Technical Service Bulletin: tsb100720

New Fuel Return Bracket

Figure 2: New fuel return bracket, Part Number 4985465.

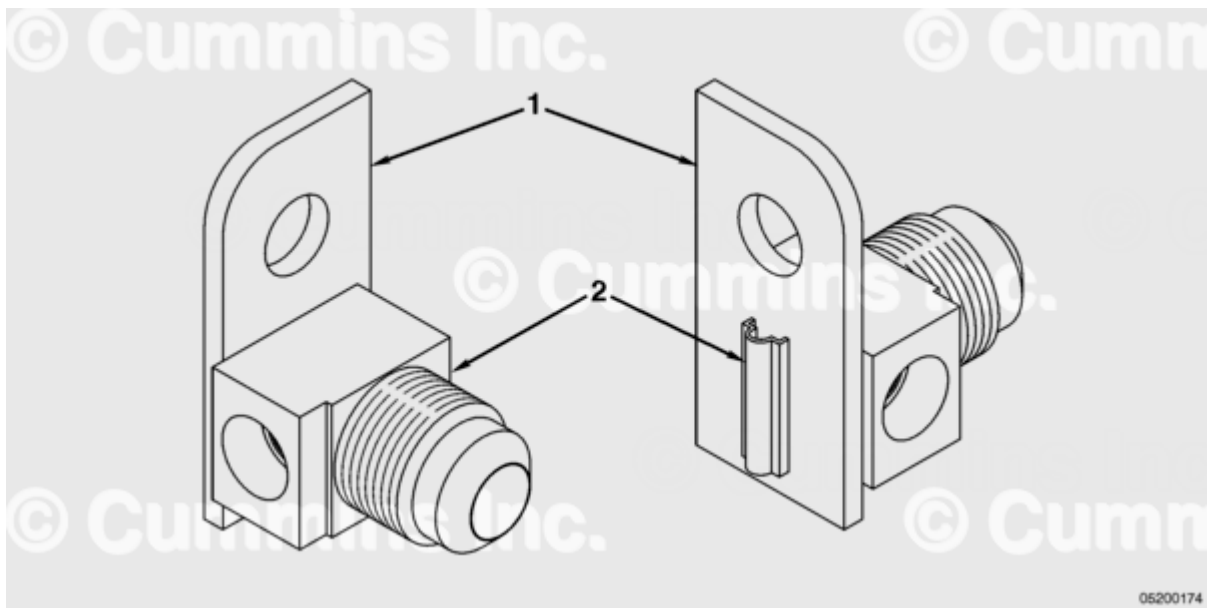
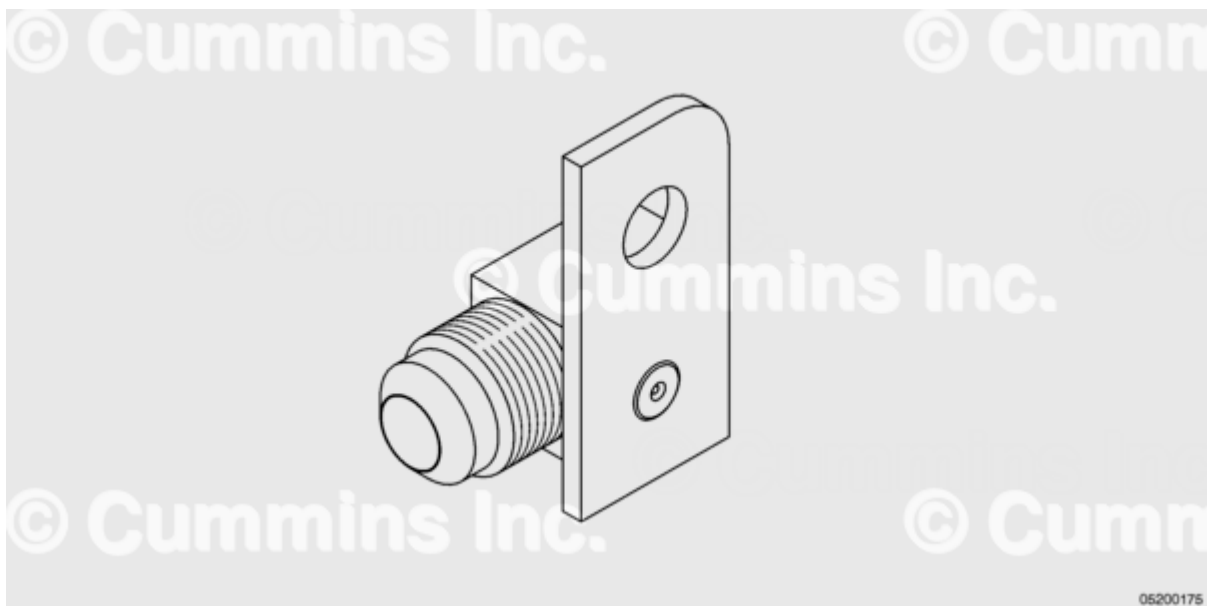
This Technical Service Bulletin introduces a redesigned ISM fuel return line mounting bracket. Previous ISM fuel return brackets utilized a rectangular staked brass fitting to secure the fuel return line and fitting to the engine block. The redesigned ISM fuel return bracket includes a round, staked, and brazed steel fitting to secure the fuel return line to the engine block. This new fuel return bracket is being released for all ISM, ISMe, and QSM engines as a new part and replaces all previous parts. The new ISM fuel return bracket, Part Number 4985465, supersedes Part Number 3401236. Reference Figure 1 and Figure 2 for the differences between the old ISM fuel return bracket and the new ISM fuel return bracket.

The release date for the new ISM fuel return bracket for production is June 2008.

The release date for the new ISM fuel return bracket for service is July 2008.

The engine serial number (ESN) first is 35233686.
